First-Party Response to Third Party Appeals

Prepared in Relation to Third-Party Appeals made Against Dublin County Council's Decision to Grant Planning Permission for a Development at Milltown Park, Sandford Road, Dublin 6.

RE: FIRST-PARTY RESPONSE TO 2 No. THIRD-PARTY APPEALS AGAINST DUBLIN CITY COUNCIL'S DECISION TO GRANT PLANNING PERMISSION FOR A PROPOSED DEVELOPMENT AT MILLTOWN PARK, SANDFORD ROAD, MILLTOWN, DUBLIN 6

Figure 4.1:

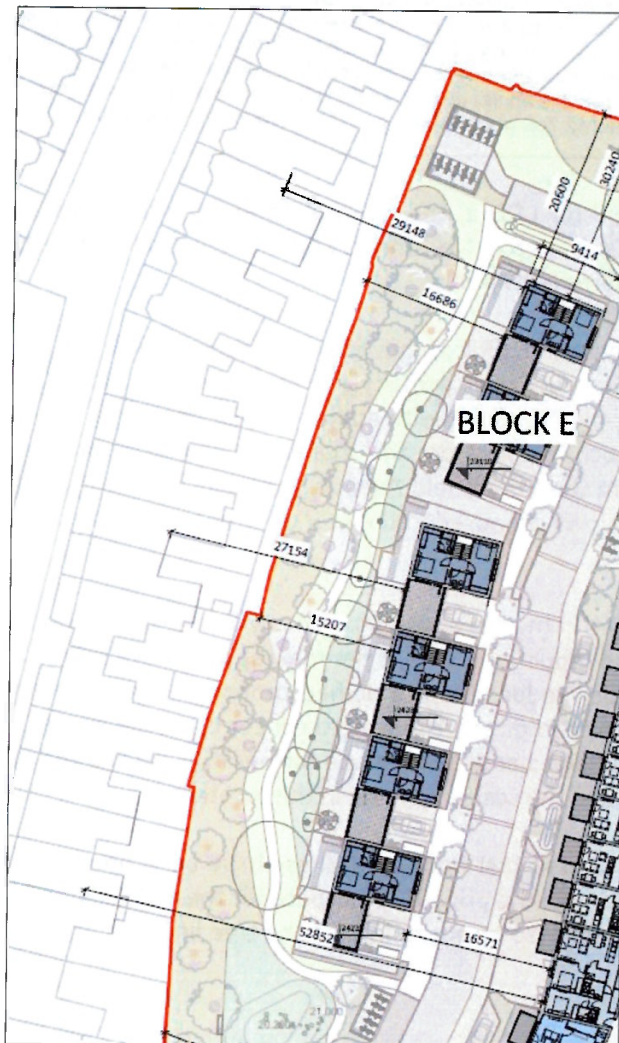
The attached Planning Objection report has confirmed the adverse impacts Block E would have on the established residential and visual amenities of our client's residents' properties. The report has also shown how Block E's removal from the scheme would improve the scheme. The Commission has already removed part of Block E in the SHD decision as it was unacceptable – it is not clear how the rest of Block E is any more acceptable than the removed part (now retained by the applicant). Block E needs to be removed to allow trees and open space to be sited in its place which offer screening to Cherryfield Avenue Lower and Upper.

If ACP wishes to retain Block E then given concerns over the duplex units having poor amenity views to the rear and so on, why not remove the first floor entirely and all overlooking terraces. This would reduce the adverse impacts arising for our client's residents.

Extract from Proposed Site Layout Plan Level 01 demonstrating the Separation Distances between the rear of Block E and the first floor windows on Cherryfield Avenue.

The Applicant acceded to this request in LRD 2; they changed the scheme from 24 No. 3 storey duplex units to 6 No. 2-storey flat-roof courtyard style houses, they have largely retained the tree line behind the houses, supplementing it with additional planting, and they have set the reduced scaled houses back much further from the shared boundary, facilitating some c. 30 metres separation distance from the Cherryfield Avenue opposing first floor windows, noting that there are no first floor windows proposed in the rear opposing elevation of the proposed courtyard houses.

A separation distance of up to c. 30 metres between opposing 2 No. storey houses is extremely generous and with setbacks of c. 15-16 No. metres within the Applicant's boundary, they have (a) provided a setback of almost twice that required in the Compact Growth Guidelines of 8 No. metres within their own boundary and (b) not taken the opportunity to provide a height that has the potential to be at least 3 or 4 No. storeys due to the substantial separation distances proposed; rather they have provided only 2 No. storeys, with a flat roof and no first floor windows in the rear elevation.

Figure 4.3: Details of Landscape Treatment of the Western Boundary

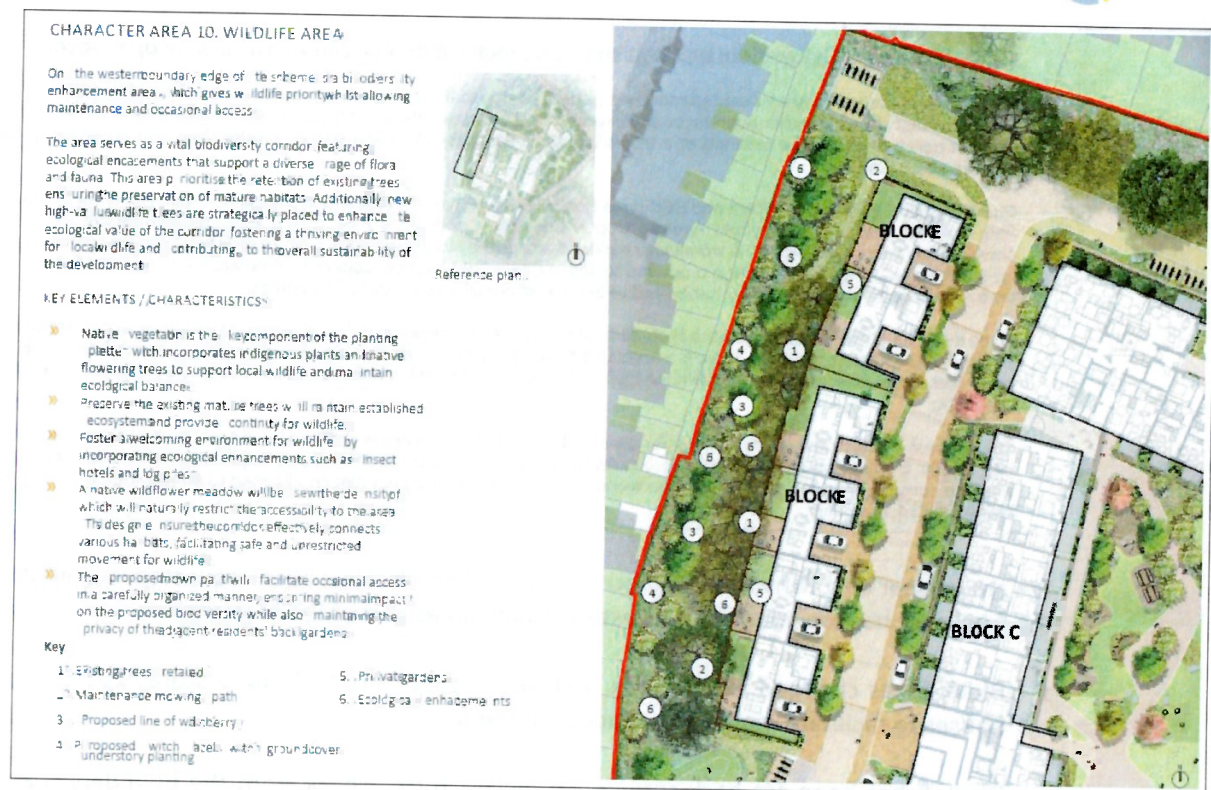
ACP is asked to require the applicant to provide a better balance to this scheme and to offer our client's residents the same respect as that shown to other boundaries which are served by tree buffers and/or landscaped open space setbacks. The western tree belt should be retained or a tree-filled open space/public open space corridor sited and designed to the western site boundary.

In the interests of fairness, balance, the protection of residential amenities and the mitigation of the adverse impacts of this scheme on our client's residents, there is a need to offer landscaped, and tree-filled screening of the scheme from adjoining properties to the west at Cherryfield Avenue Upper. The proposed 1.8m tall boundary treatment is not going to provide any screening.

We are unclear as to why this is a ground of appeal as what has been requested is **exactly** what the Applicant has provided on the western boundary as part of the Masterplan:

3. The western tree belt has been very largely retained and has been supplemented by additional planting, with Block E provided behind this tree line to protect the residential amenity of the Cherryfield Avenue dwellings.

5. As the space along the western boundary is proposed as a biodiversity corridor (as requested in Ground 4), it has not been included in the calculation of usable public open space for this reason and provided is in addition to the 35% + public open space on this site.

Figure 4.4: Location of Nearest High Frequency Urban Bus Services to the Subject Site (Indicatively Outlined in Red)

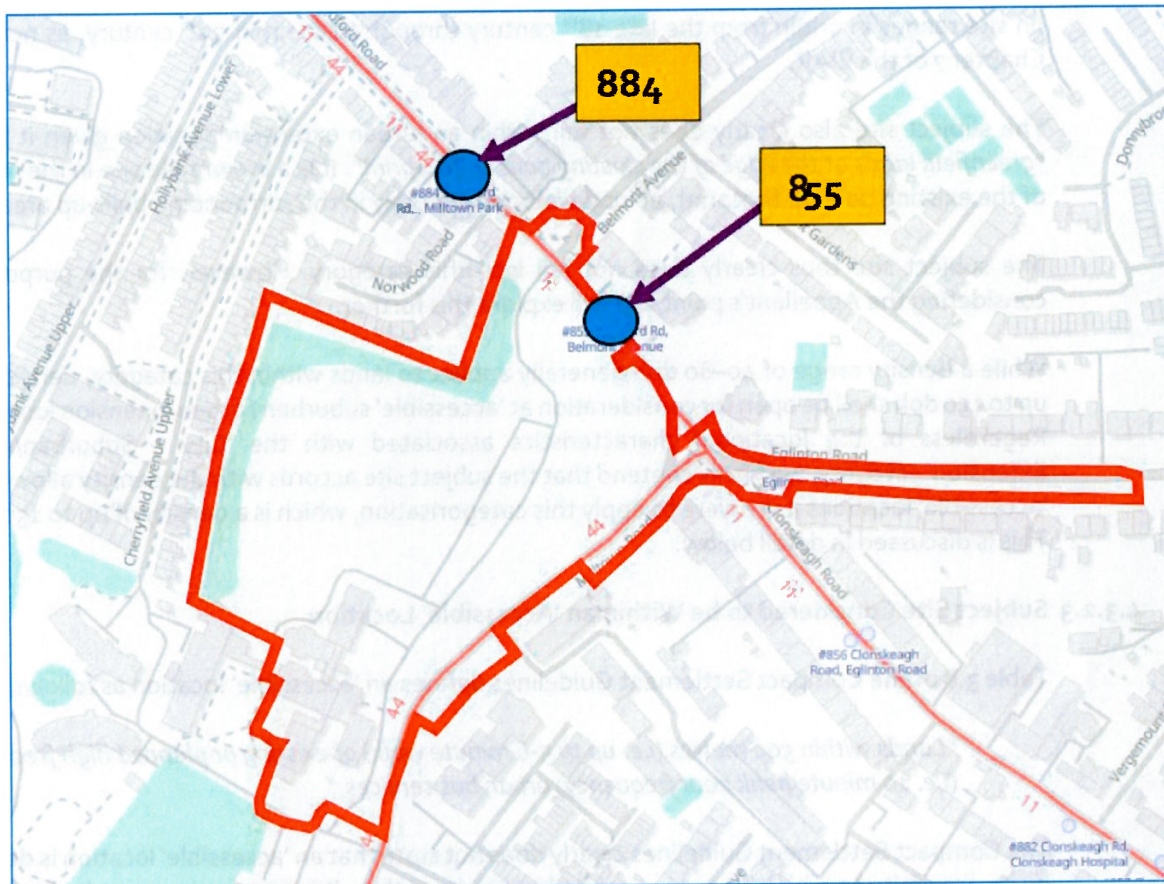
The Appeal states that the subject site is "*more than 700 m from the nearest high frequency urban bus service on the N11 Stillorgan Road*". However, this is incorrect as the nearest high frequency (10-minute peak hour frequency) urban bus services of the subject site are bus stop Nos. 855 & 884 which are located approximately 20-metres and 70-metres respectively from the subject site (less than a minute's walk) along Sandford Road. The location of these bus stops is illustrated in Figure 4.4 and details of the bus routes serving each stop are presented in Table 4.1.

There are also several future bus routes that will be delivered in proximity to the subject site under the BusConnects programme. The No. 86, 87 & 88 'Radial' bus routes will operate along Sandford Road. The No. 86 will provide a half-hourly weekday service and half-hourly and hourly weekend service between Ticknock, Goatstown and Mountjoy Square. The No. 87 will provide an hourly weekday and Saturday service between Belarmine, Dundrum and Mountjoy Square. The No. 88 will provide an hourly weekday and weekend service between Enniskerry, Belarmine, Dundrum and Mountjoy Square. Although it is not yet known what stops will facilitate these bus routes, it is likely that they will operate at existing bus stops along the identified route, including stop Nos. 855 and 884, further increasing the frequency of bus services serving the subject site.

Figure 2.1: Highlighted positions of the assessed windows of 5 and 6 Norwood Park (L). Aerial view of assessed location (R)

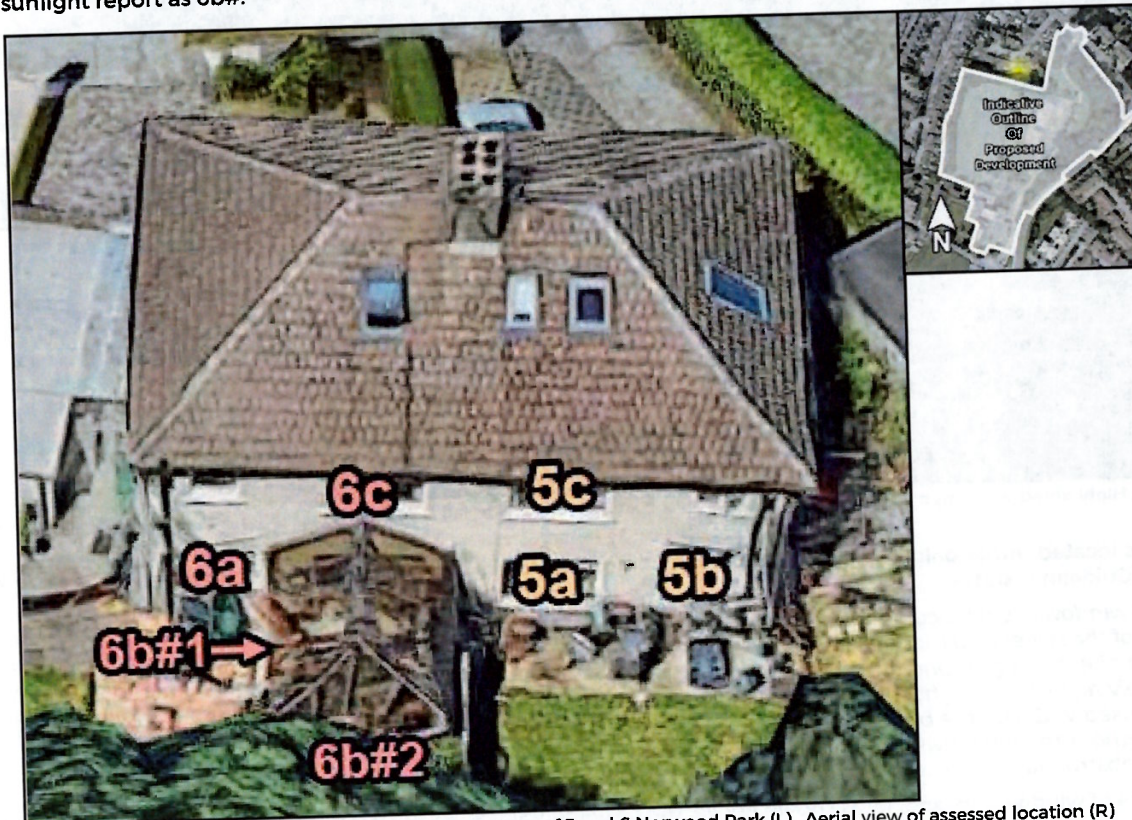
As shown in Figure 2.1 below, there is a room to the rear of 6 Norwood Park, identified in the submitted daylight and sunlight report as 6b#.

This room has two windows, one facing west (window 6b#1), and the other facing south (6b#2).

Figure 2.2: Highlighted positions of the assessed windows on the 1st floor of Rowan Hall / Cedar Hall (L). Aerial view of assessed location (R)

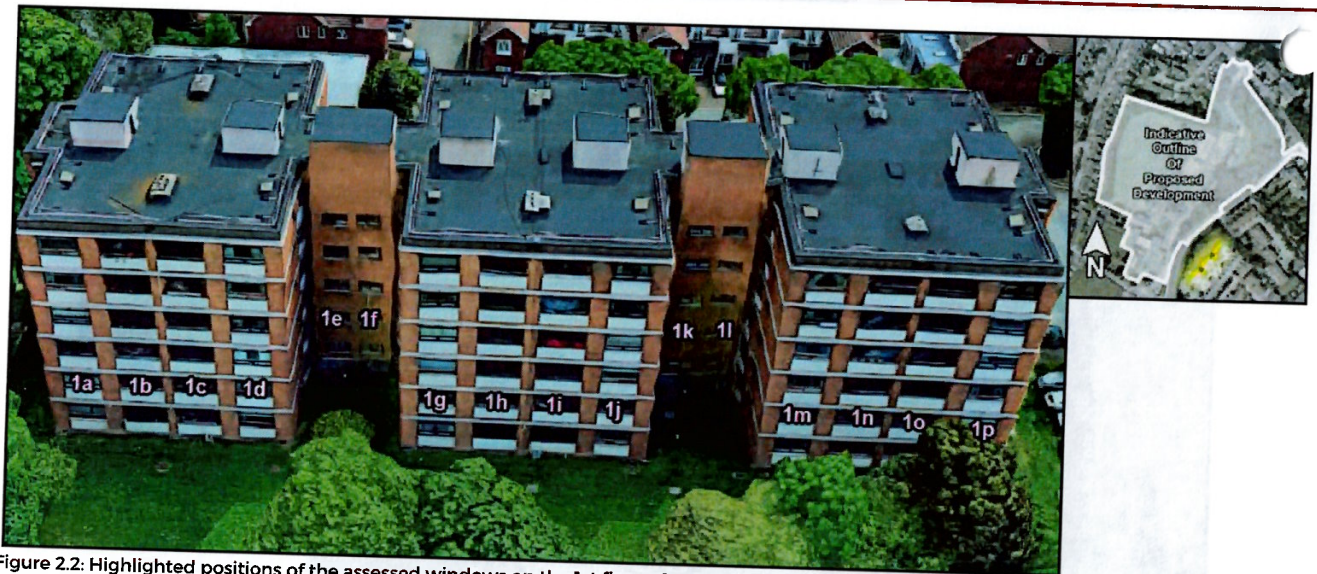
This has been rigidly applied to the presentation of results throughout the submitted daylight and sunlight report. This is best demonstrated in the VSC results for the 1st floor windows of Rowan Hall / Cedar Hall. As shown in Figure 2.2 on the following page, this development contains multiple windows that are within recessed balconies.

Windows located under balconies are generally constrained in terms of daylight access. Regarding this, section 2.2.13 of the BRE Guidelines states:
